**Errata: CS4341 Rev. C****CS4341 24-Bit, 96 kHz Stereo DAC with Volume Control**

All references to the CS4341 mentioned below shall be taken to refer to revision C of the CS4341 product. The hardware revision code can be found in the 10 character field printed below the part number on each chip. The letter which appears as the fifth character from the right is the revision code (e.g. ZNACSC9926 is a Revision C part).

Figure 1. I<sup>2</sup>C SCL Buffer Example

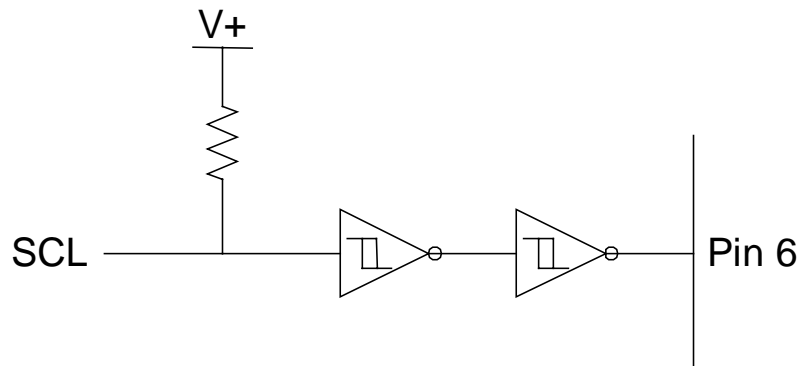
Pin 6 (SCL/CCLK) of the CS4341 does not have sufficient hysteresis to meet the data sheet rise time specifications. The I<sup>2</sup>C rise time  $t_r$  and the SPI rise time  $t_{r2}$  must be less than 30 ns for proper operation. This prevents the use of standard I<sup>2</sup>C configurations with a resistor pull-up. This problem can be worked around by placing a Schmitt Trigger buffer, for example a 74HC14, on the SCL line just prior to the CS4341. This will not affect the operation of the I<sup>2</sup>C bus as pin 6 is an input only.
